MEETING SUMMARY NOTES

Date: January 16, 2020

RE: Questions concerning Badger Army Ammunition Plant

Mercury Isotope-Source plot for Sediments (from U.S. Geological Survey presentation to the BAPP RAB, September 2019)

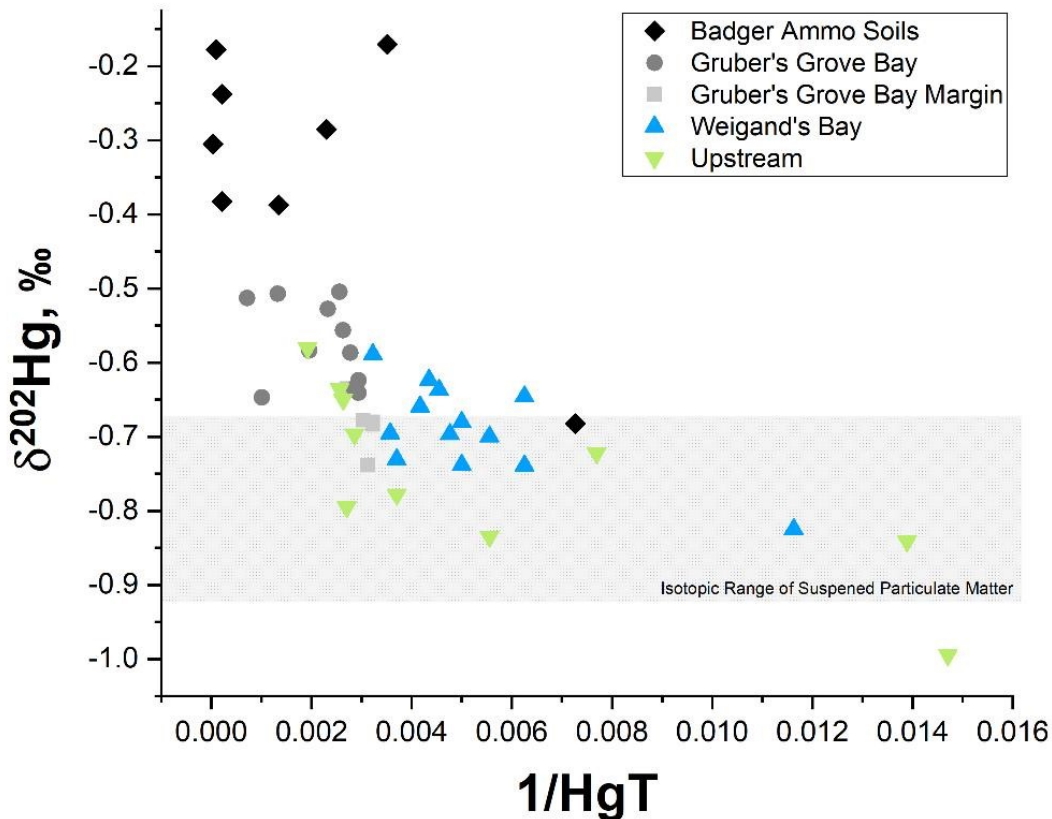
11. Where is the source of the mercury?

In May of 2019 the USGS performed field sampling within Gruber's Grove Bay (GGB), Weigand's Bay, upstream sites, and on site at the Badger Army Ammunition Plant (near former settling ponds). Sediments and suspended particulate matter were collected from GGB, Weigand's Bay, and upstream sites. Soils were collected from former settling ponds. The objective of the sampling was to determine the source fingerprint (isotope signatures) of mercury from the Gruber's Bay region and the extent of contamination. Isotope signatures are independent of mercury concentration and can be assessed on a scale from terrestrial to industrial sources.

The figure below shows that mercury isotope signatures collected by the USGS from the BAAP soils are the most positive and likely are indicative of the original source of mercury from the BAAP. Sediments from GGB show similar characteristics to these soils but are less negative suggesting the influence of mercury releases from the plant as well as the accumulation of mercury from the Wisconsin River. Sediments from Weigand's Bay and Upstream sites represent the isotopic fingerprint of mercury within the Wisconsin River and are similar to suspended particulate matter (gray box) collected from the water column.
